Re:- Add: to the building on Plot No. 15/56, J.M.-3, for Hyderabad
Amil Co: Housing Society Ltd.

Case No. P/C 350/34

Reference No. B. S. P. 350/34

THE PROPOSED ADDITIONS & ALTERATION IN THE BUNGALOW

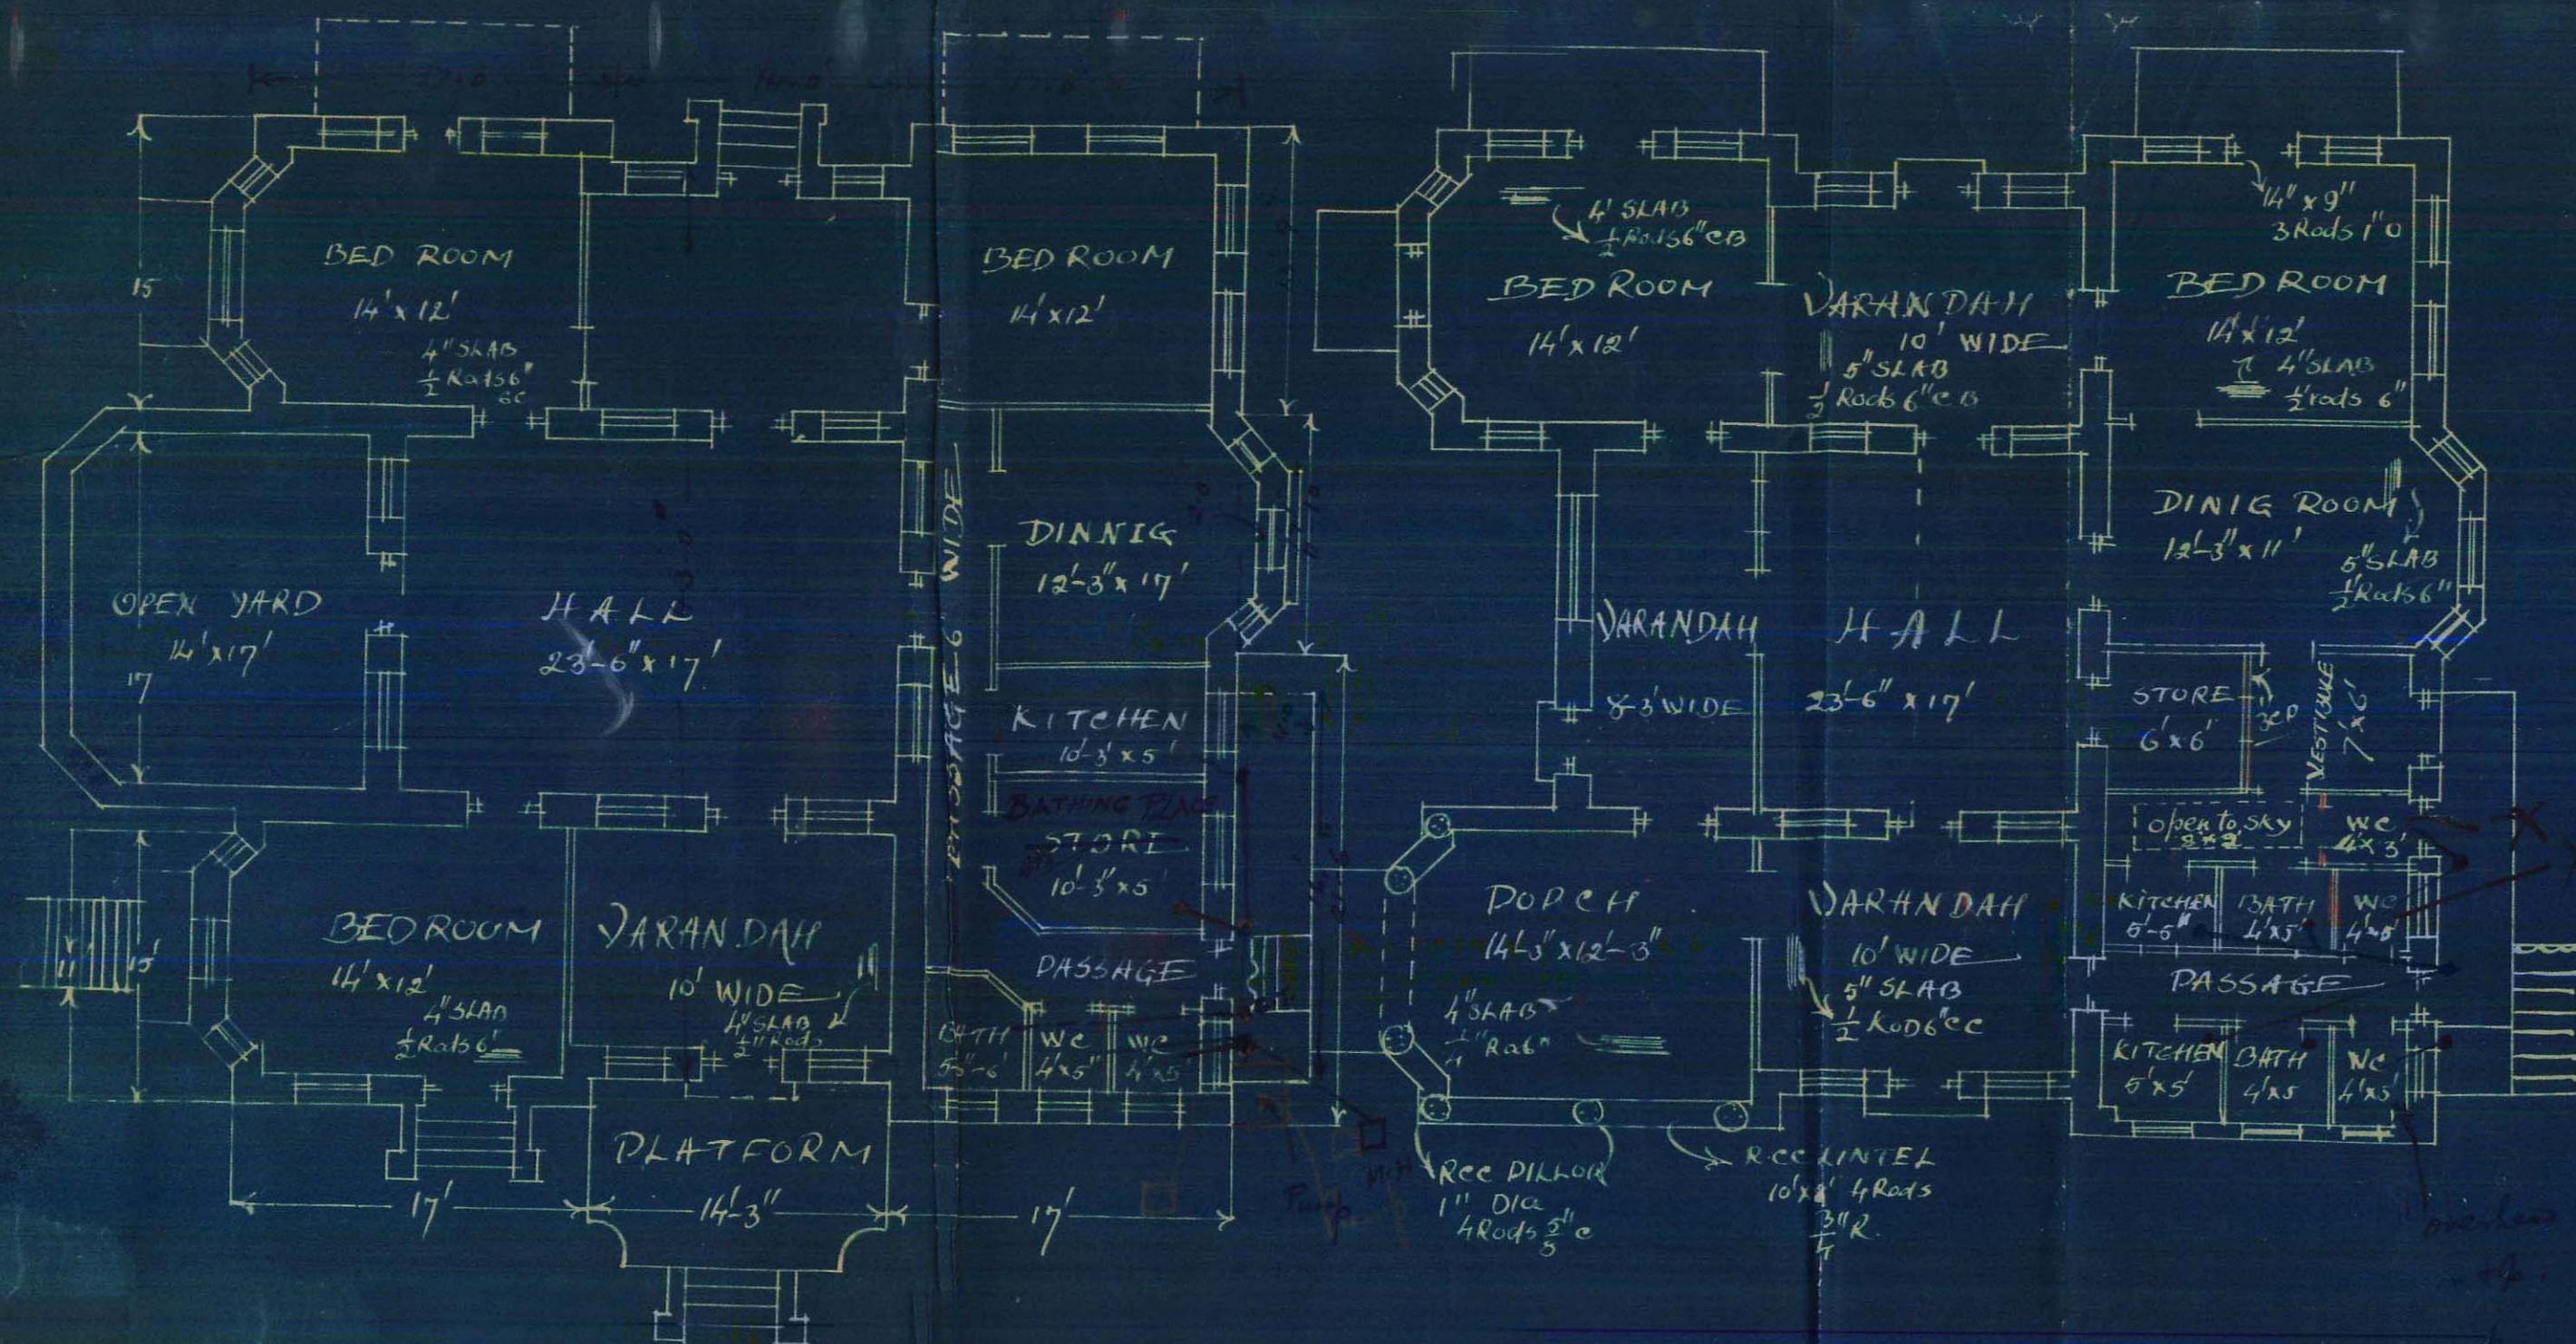
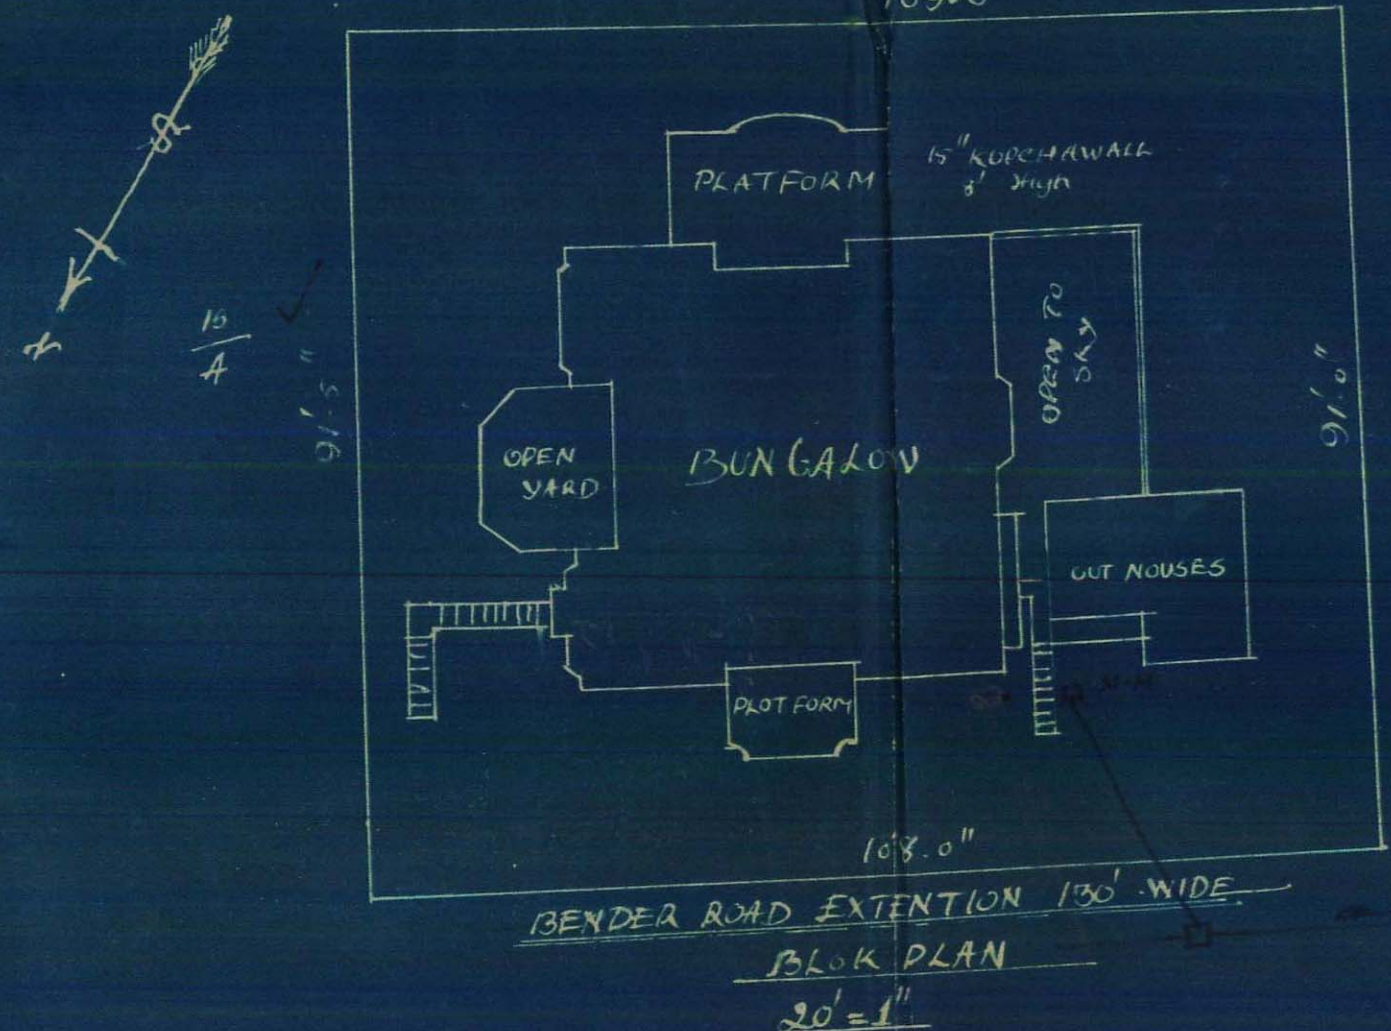
N.C. marked & are over the store rooms, which is not allowed. Besides fields & acts under the same.

*Drainage lines should be
shown on the plan also the
position of overhead Tank & the
access to it.*

Plot no. must be corrected

1. Compounds must be level & filled to the road level outside
2. Application be made on form A
3. Correction in measurements be made as shown in red ink on the plan.
4. W.C. over store cannot be allowed.
5. ~~Back & kil'cham~~

- ✓ 1. W.C.s marked X over the store rooms which is not allowed; besides kitchens and baths will be dark. *will not be*
- ✓ 2. Drainage lines should be shown on the plan; also the position of overhead tanks and the access to it. *no objection*
- ✓ 3. Plot no. must be corrected. *Mr. 13*
- ✓ 4. Compound must be level and filled in to the road level outside. *no objection on plan*
- ✓ 5. Application be made on form "A"
6. Correction be made in measurements as shown in red xx ink on the plan.
